# Product Change Notification (PCN)

PCN #: 10A-2021

| Laird Part Number | Description                              |
|-------------------|------------------------------------------|
| 453-00005         | Module, BL651 Series, Integrated Antenna |

### 2.1 Change 1 – Contract Manufacturer / Location

### 5.1 Module & Adapter Labels (on device)

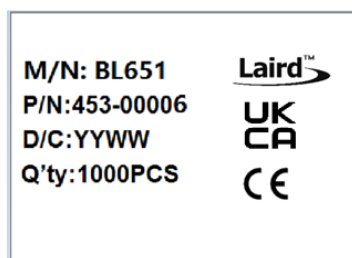
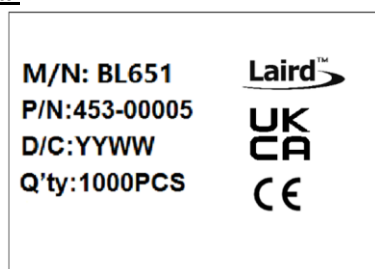
The BL651 modules (453-00005/453-00006), manufactured at **Delta**, has a date code matrix in QR code on the label that states YYMMDD1XXXXX.

The BL651 modules (453-00005/453-00006), manufactured at **Ryder**, has a date code matrix in QR code on the label that states SSYYWWDXXXXXX.

Due to the very small form factor of the product label, the manufacturer code can be found in QR code and UKCA logo is not required to be included.
